# York-Cumberland FEMA appeal Phase I Update

**Wells Town Hall  
May 22, 2018**

Town of Kittery  
Town of Wells  
Town of Kennebunkport  
City of Biddeford  
Town of Old Orchard Beach  
City of Portland  
Town of Harpswell

**RANSOM**  
Consulting  
Engineers  
and Scientists

# Portland 1% annual chance TWL

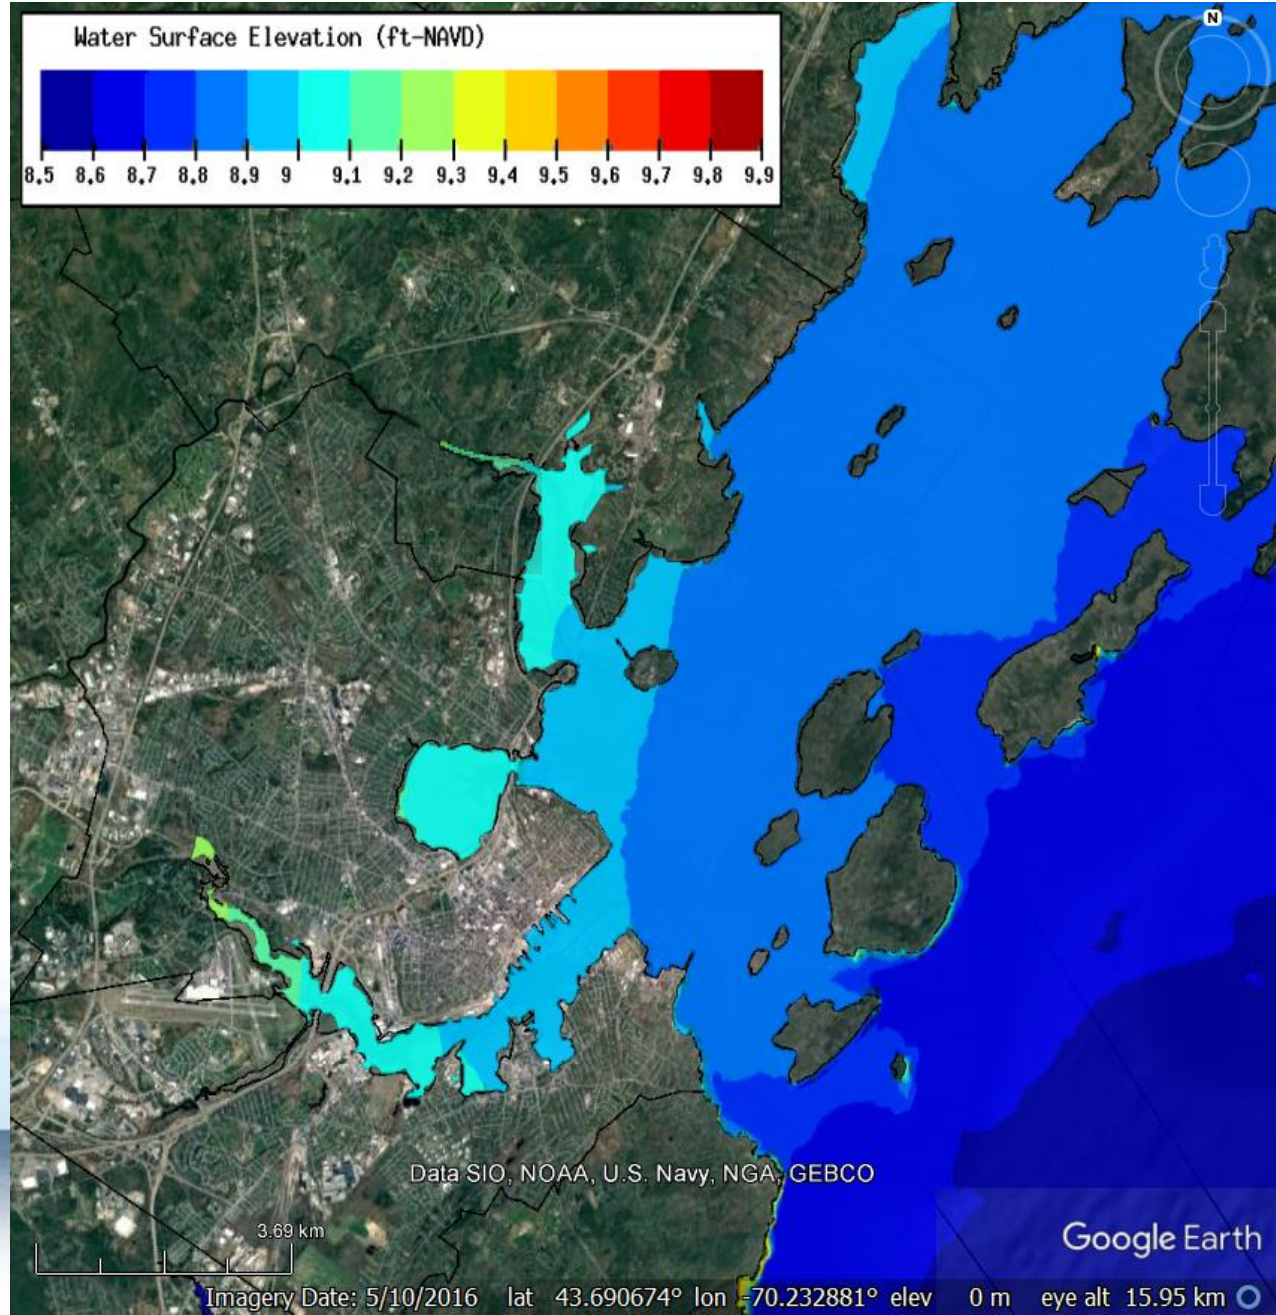
FEMA SWL = 8.9'

Wave Setup = 0.6' to 5'

FEMA TWL = 9.5' to 13.9'

# Harpswell 1% annual chance TWL

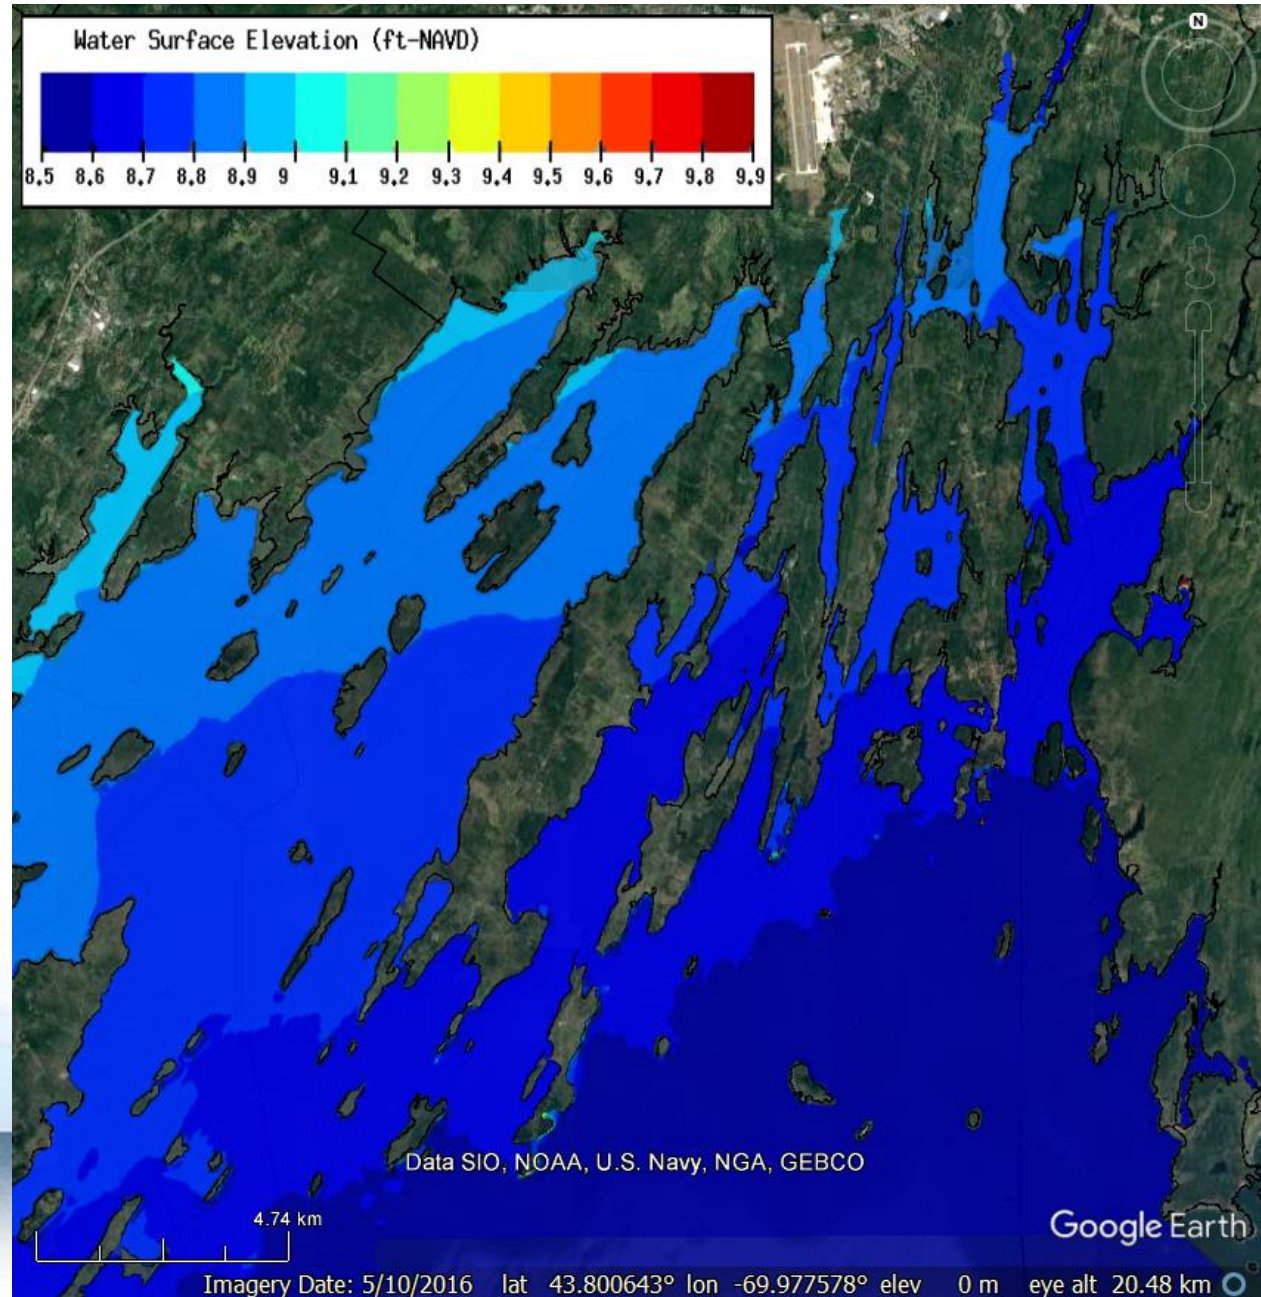
FEMA SWL = 9.1'

Wave Setup = 1' to 5'

**FEMA TWL = 10.1' to 14.1'**

# Our Proposed Wave Conditions

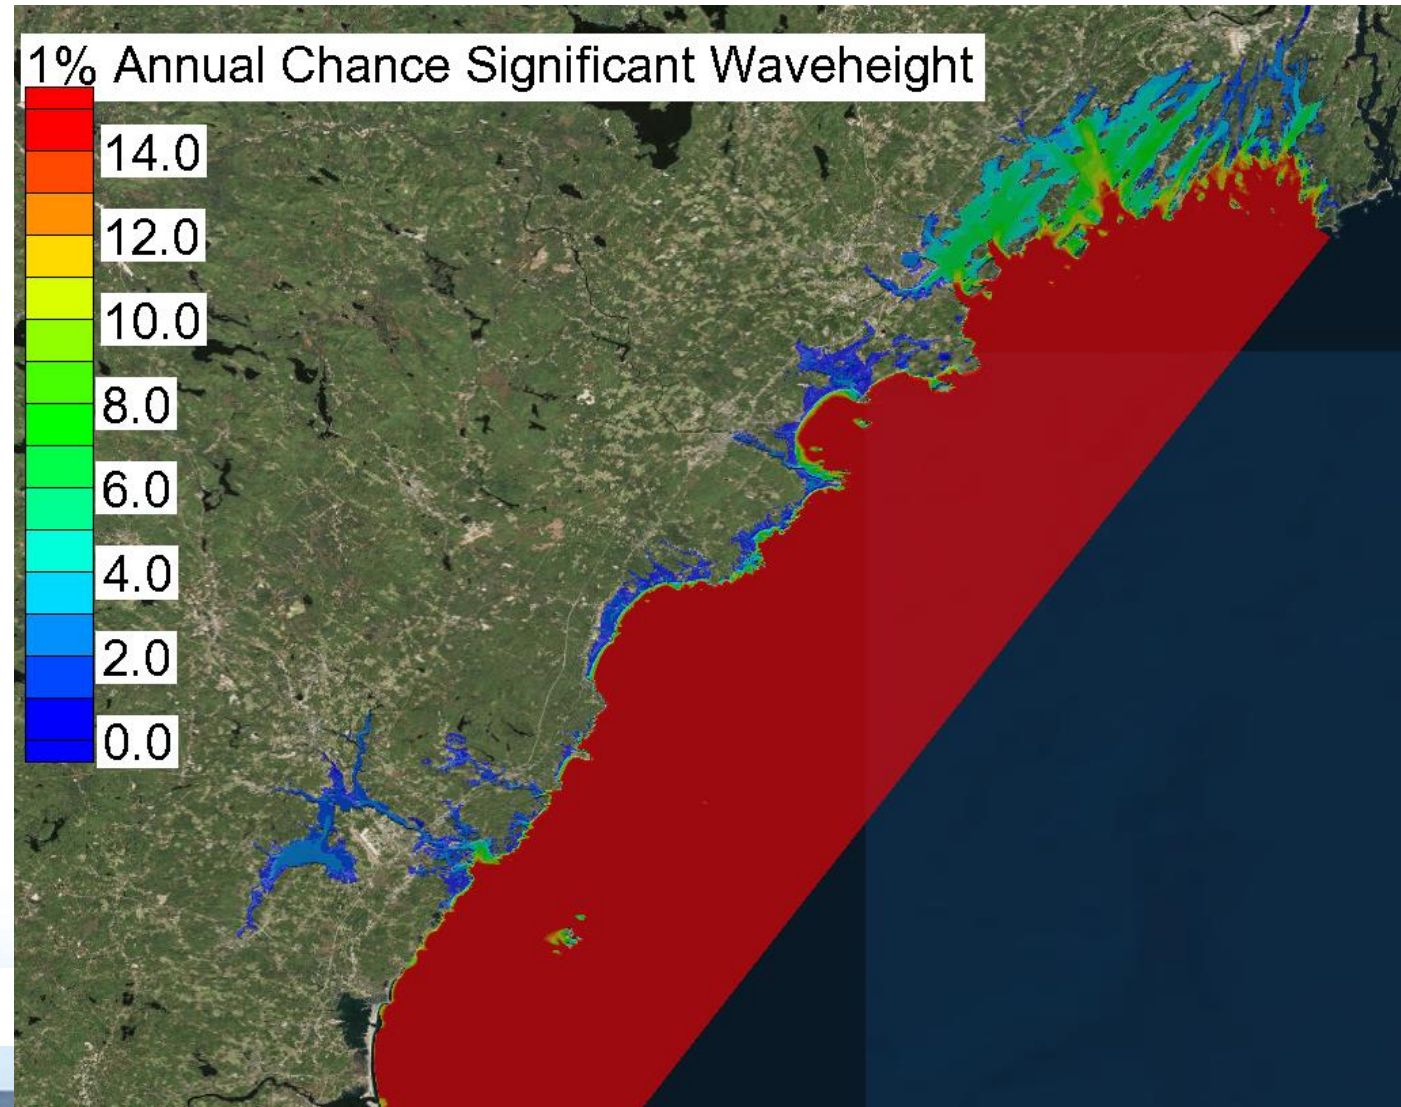
Wave Period  
based on site  
specific  
constant wave  
steepness  
assumption
